# ST. PETERSBURG COLLEGE

## PALLADIUM BUILDING

### ADDENDUM NO. 1

MATRIX PROJECT NO. 16-0610

**A3.3**

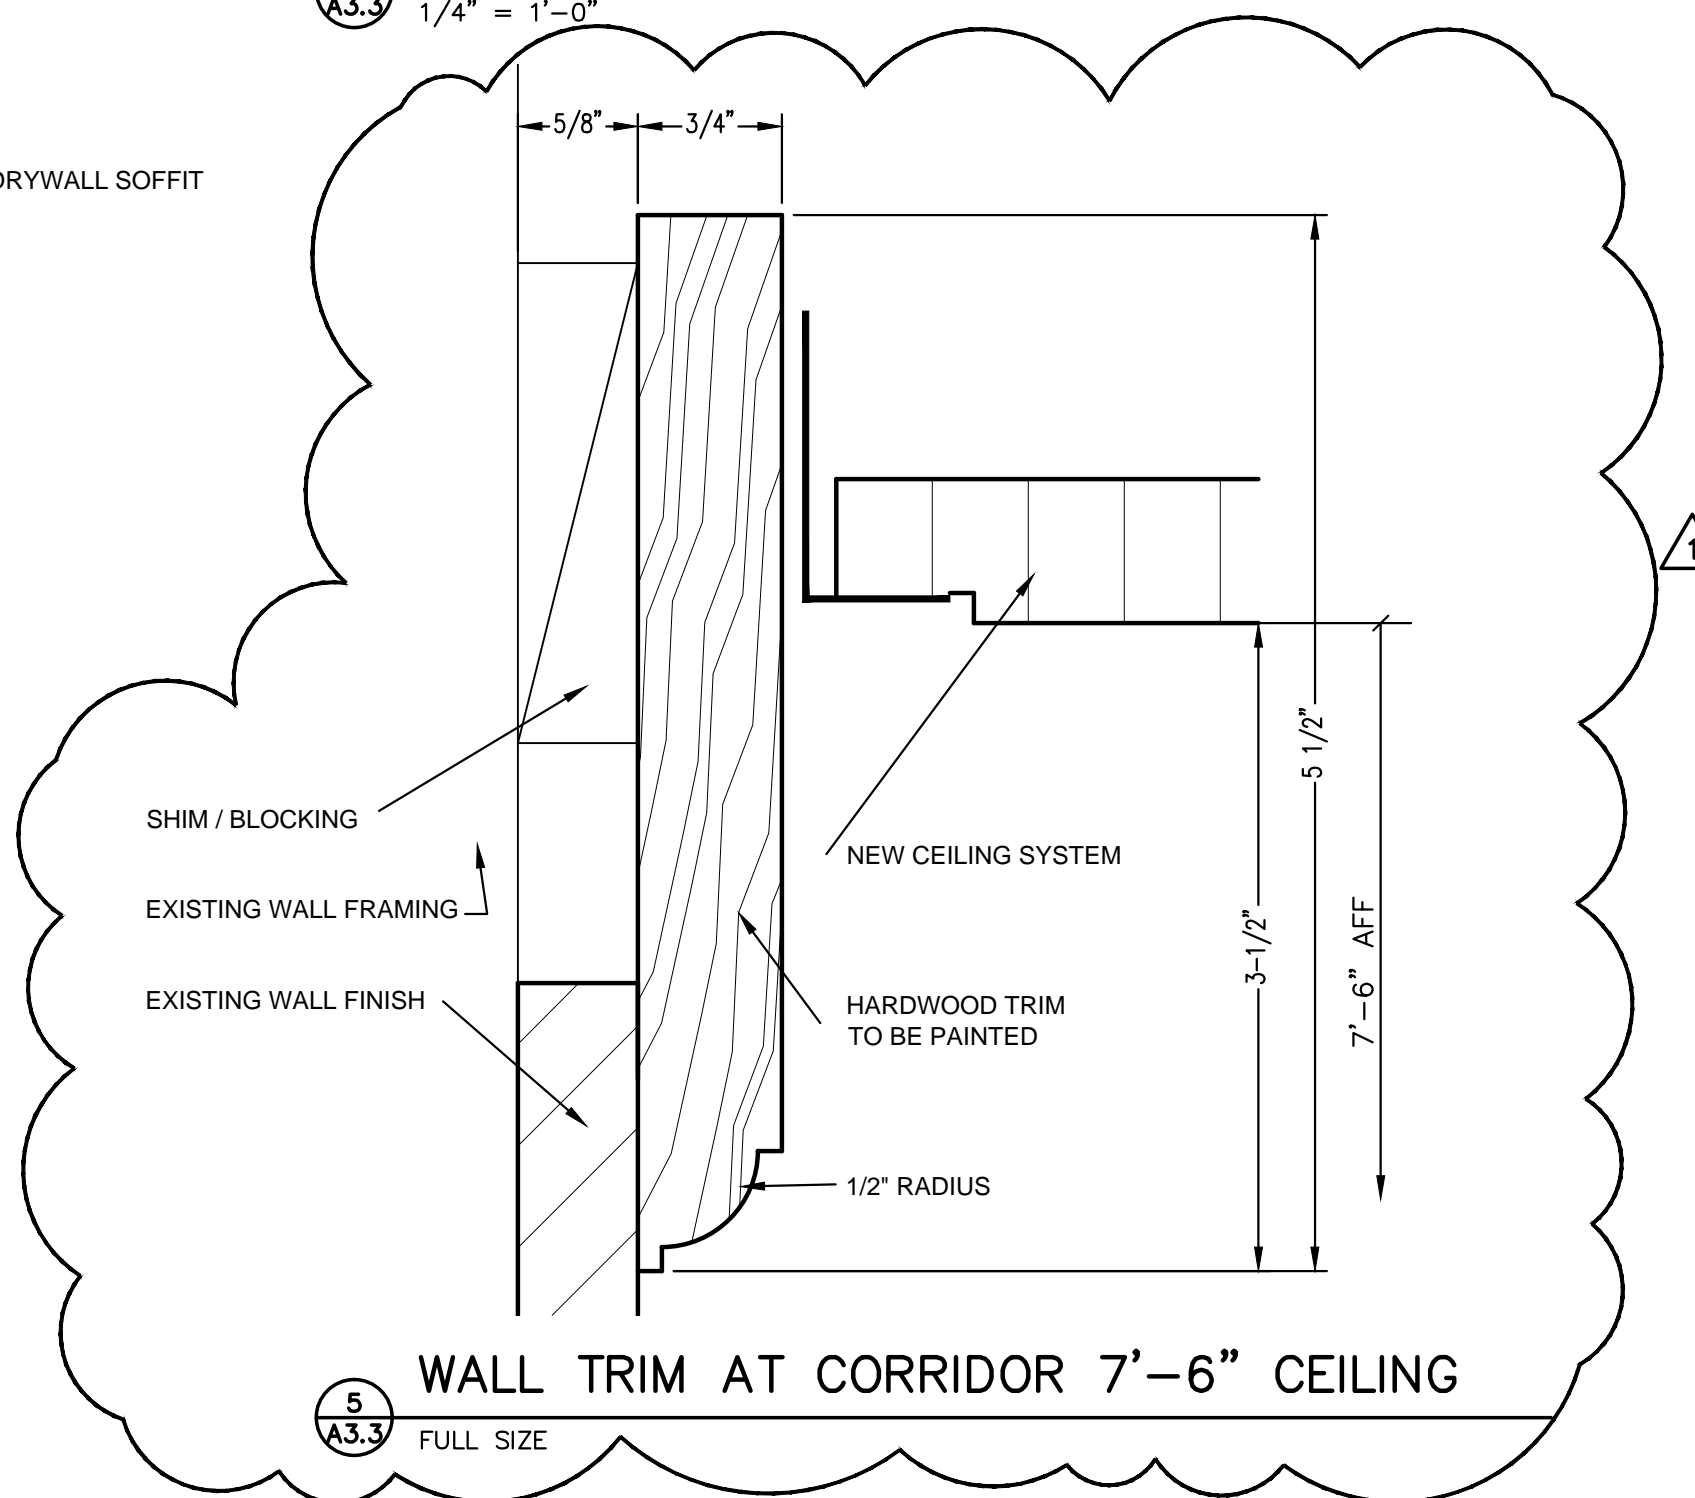
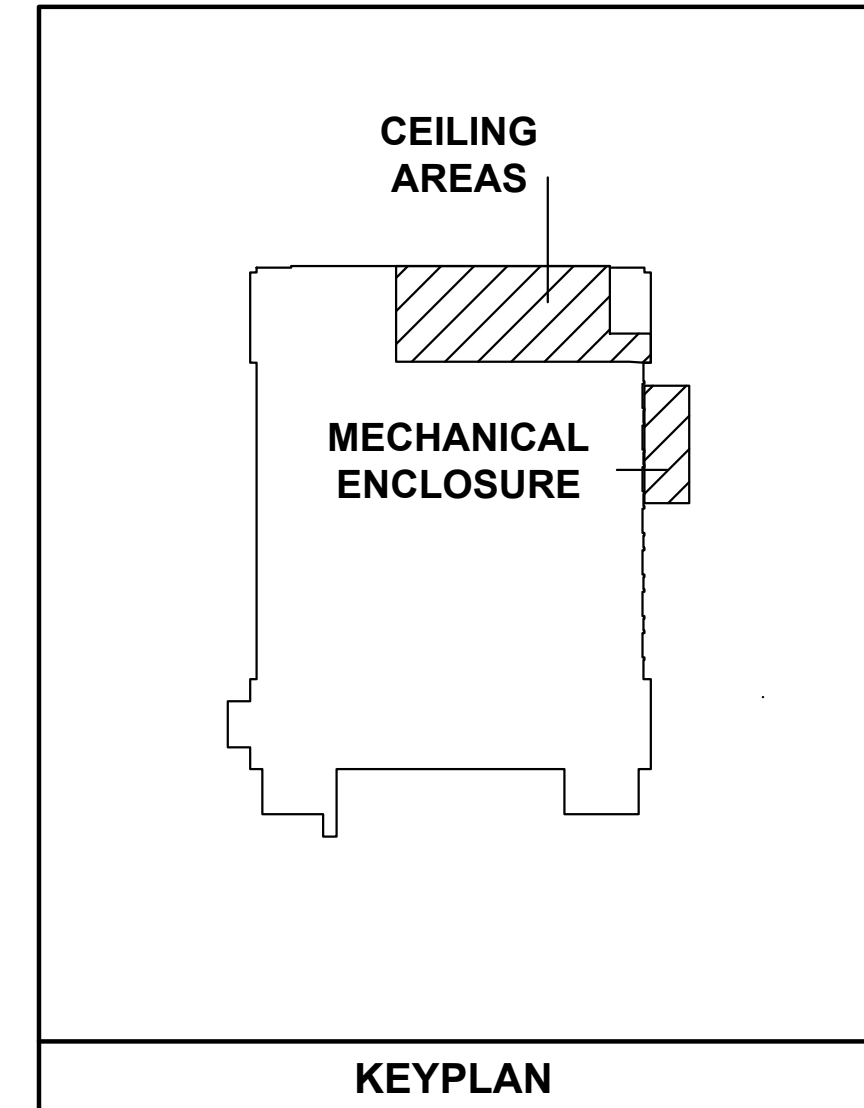
- Item 1. Drawing A3.2, Building Sections and Details
- CLARIFIED the soffit dimensions and materials as shown.
- Item 2. A3.3, Ceiling Plans and Mechanical Enclosure.
- CLARIFIED the wall trim requirements in the corridor.
  - CLARIFIED the soffit dimensions as shown.
  - MODIFIED the locations of the existing bike racks as shown.
  - CLARIFIED patching scope and locations for demolished air devices.

**E2.1**

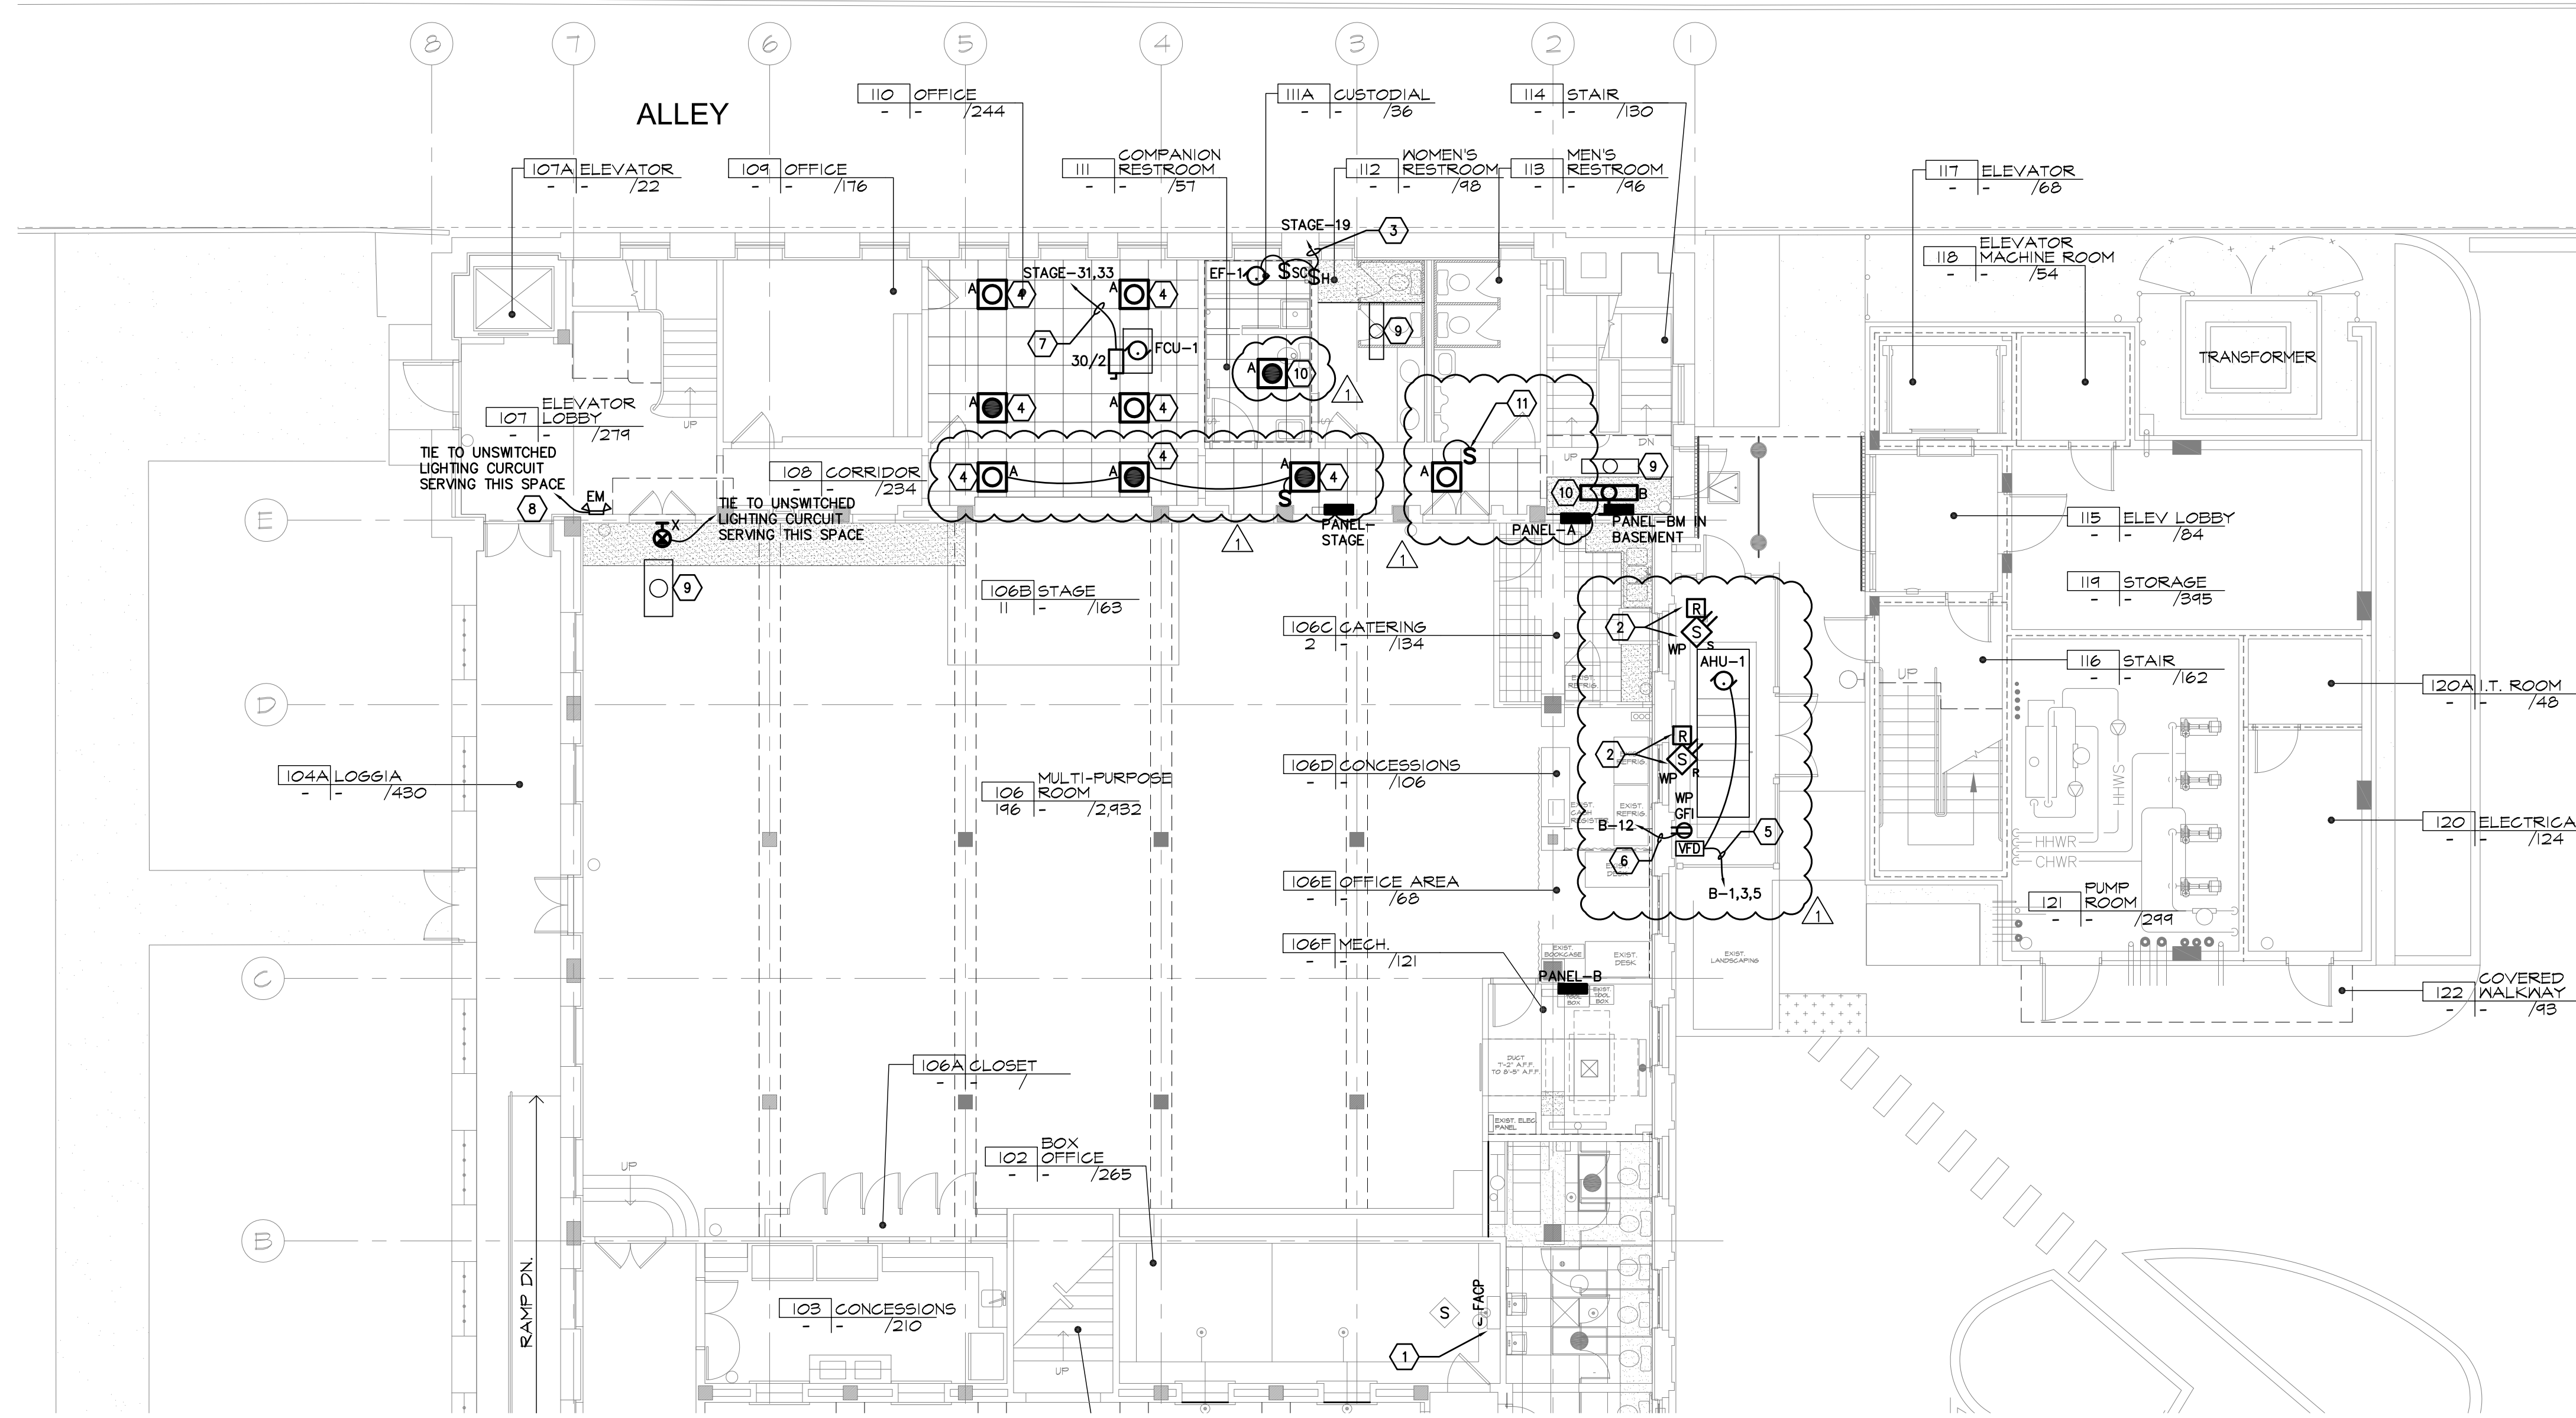
Item 5. Drawing E2.1, Electrical Floor Plan

- MODIFIED the lighting layout in the
- CLARIFIED the switch locations for the corridor lighting.

DRAWING NUMBER:  
**M1.1**

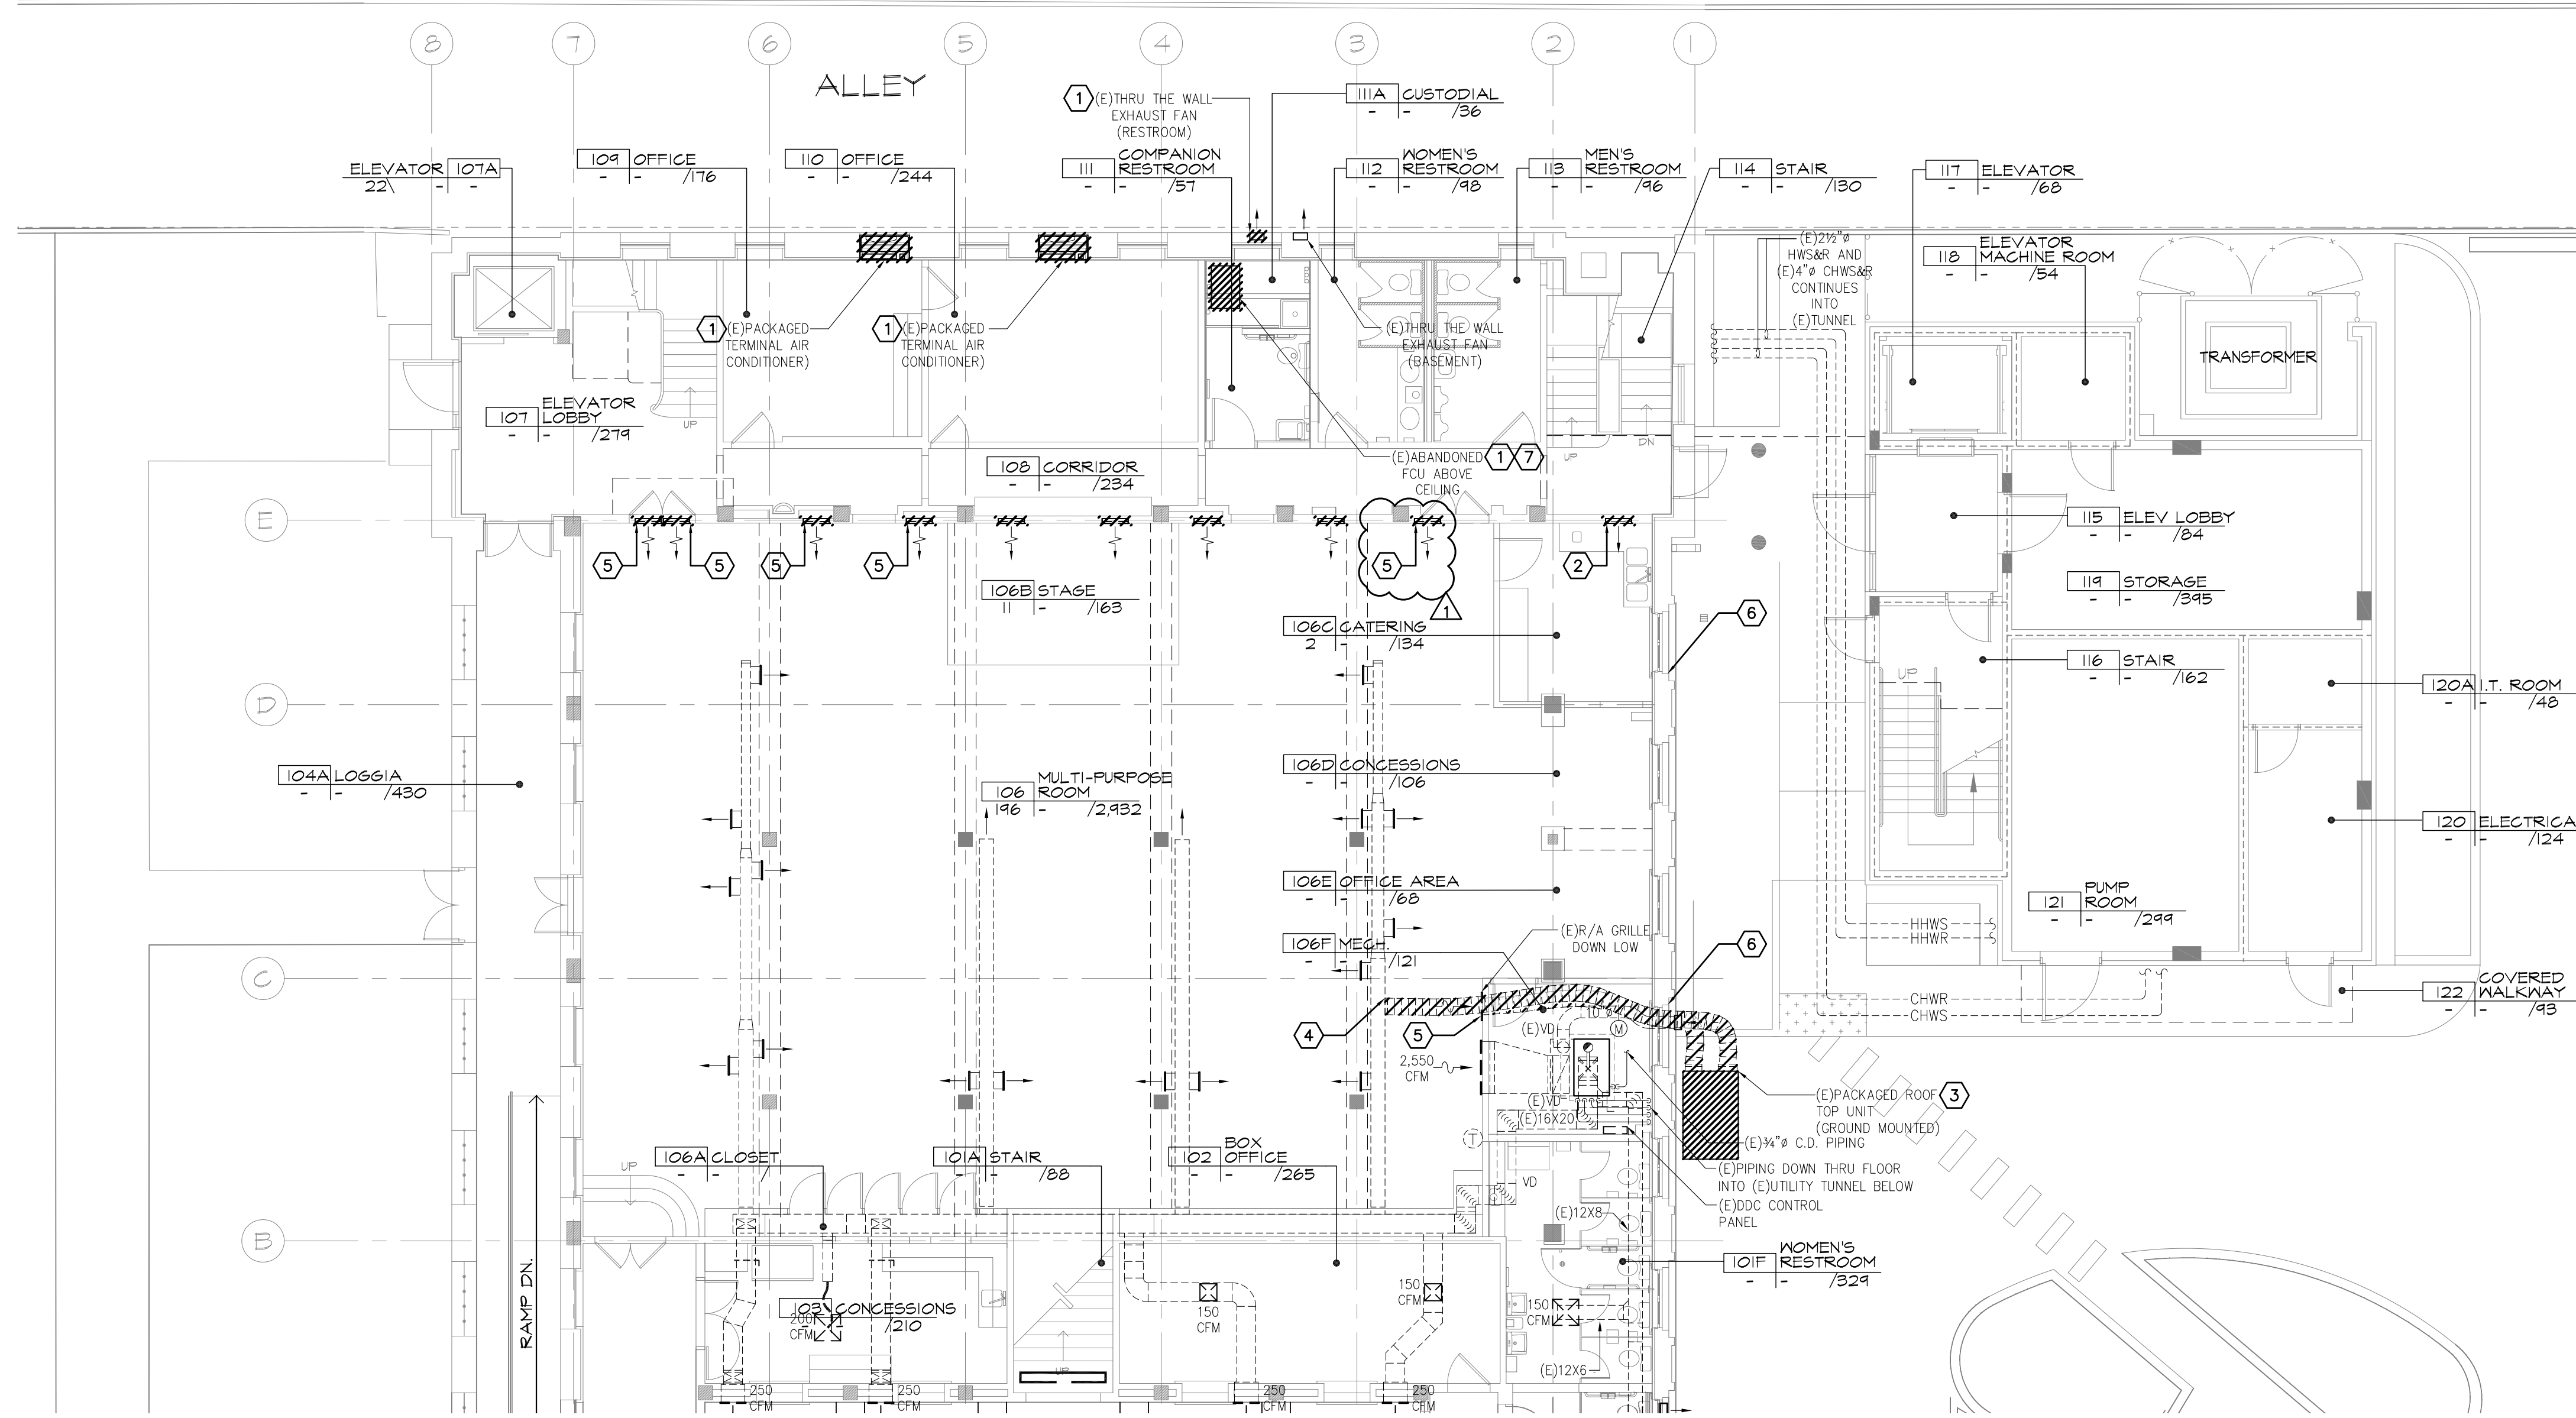
Item 3. Drawing M1.1, Partial Demo Plan - Mechanical

- MODIFIED the supply air duct sizes as shown.
- MODIFIED the quantity of demolished wall mounted supply air devices in the Stavros Room.
